REMARKS

Applicant's invention, as disclosed and claimed (for example, by independent claim 3 and substantially similarly by independent claims 5, 6, and 11), is directed to a semiconductor device.

Fig.1

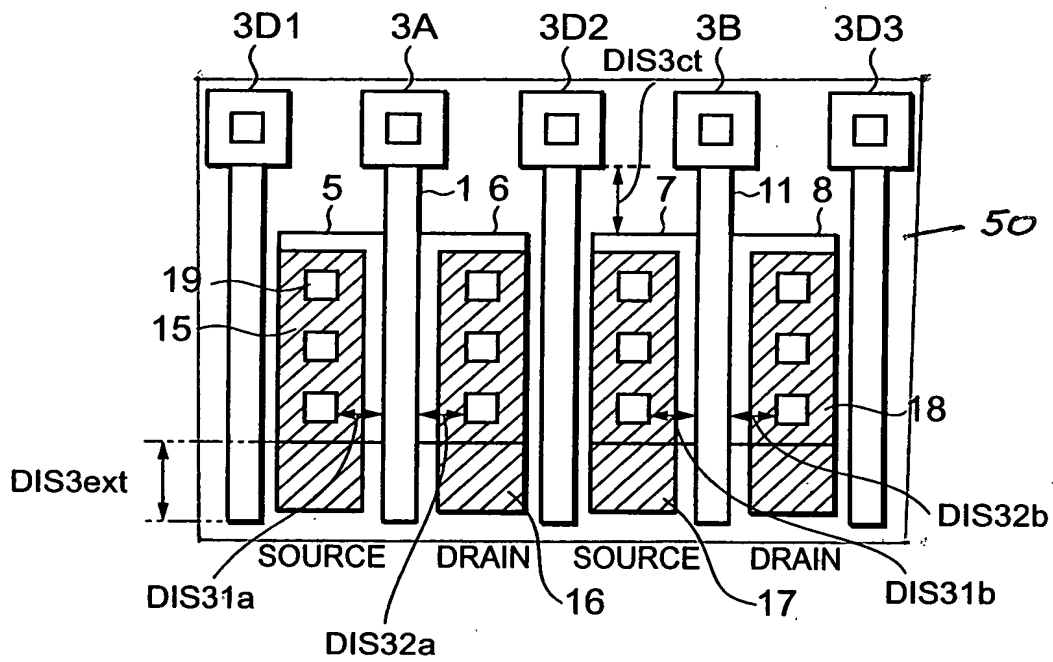
second source and a second drain. The second gate is arranged parallel to the first gate. Also, a first dummy gate is arranged between the first drain and the second source and is parallel to the first gate. Thus, as shown for example in Fig. 1 of the invention, the first dummy gate is parallel to a first gate of a first transistor and, therefore may also be parallel to the second gate of the second transistor.

In response to the Examiner's objection to the Drawings, Applicant files herewith a Submission of Proposed Drawing Corrections for Figs. 1-3 marked in red to show an element isolation region 50. Further, Figs. 6-8 have been marked in red and labeled as "Prior Art". Further, in response to the Examiner's objection to the Drawings (e.g., on page 2, item 3 of the Office Action), Applicant respectfully notes that the specification has been corrected in the Amendment filed on November 26, 2001 to clearly identify the source diffusion region 7.

Fig.2

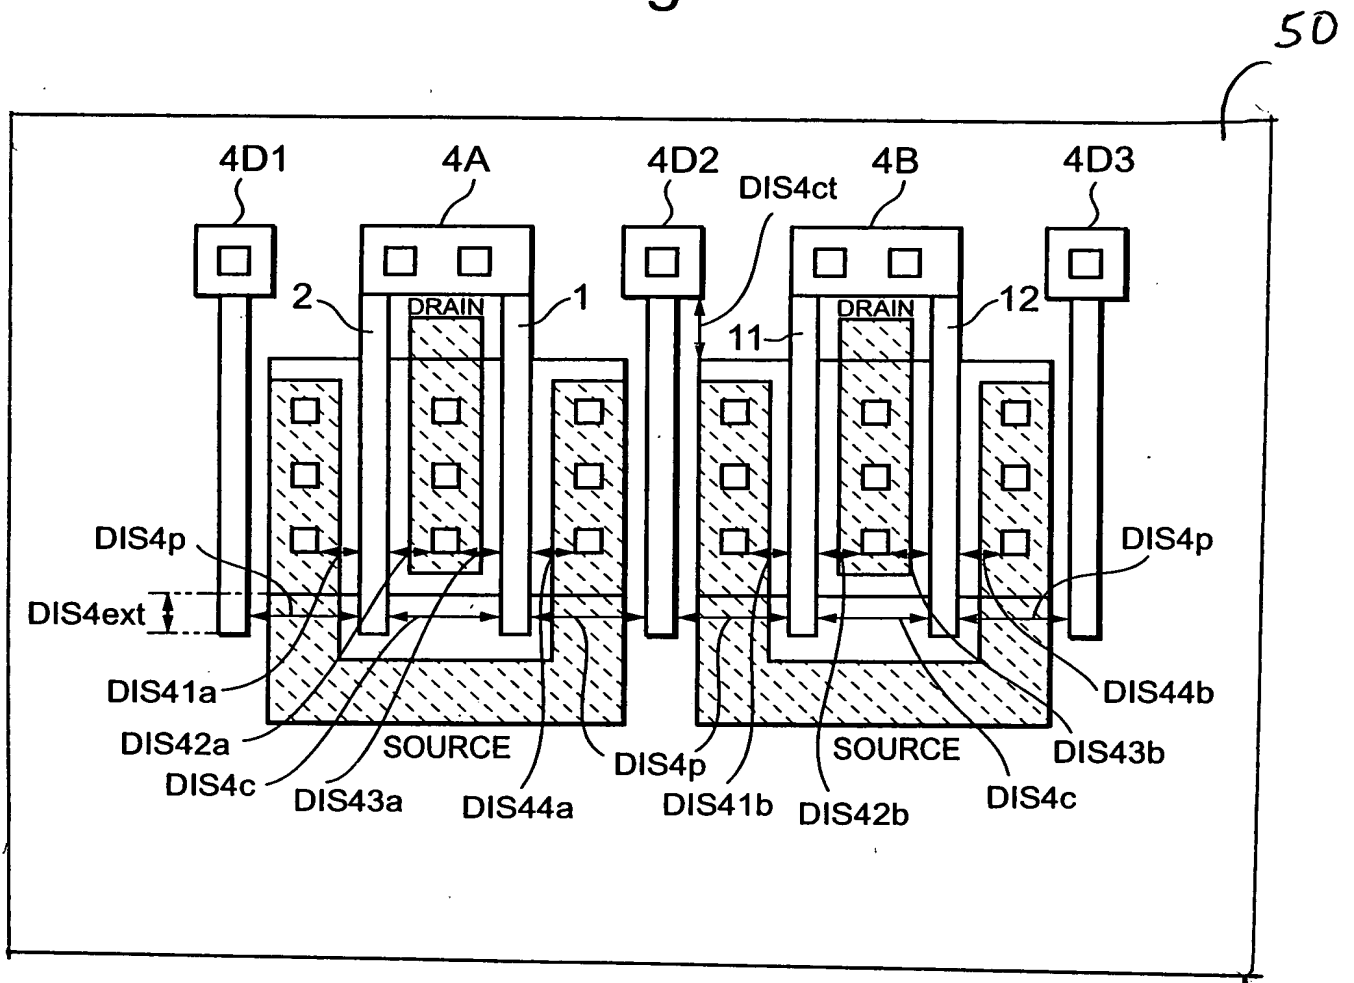
second direction is clearly shown in Fig. 2 of the present invention in which first pair transistors 4A and second pair transistors 4B extend in a second direction different from that of the first line which includes the first source diffusion region, the first drain diffusion region, the second source diffusion region, and the second drain diffusion region.
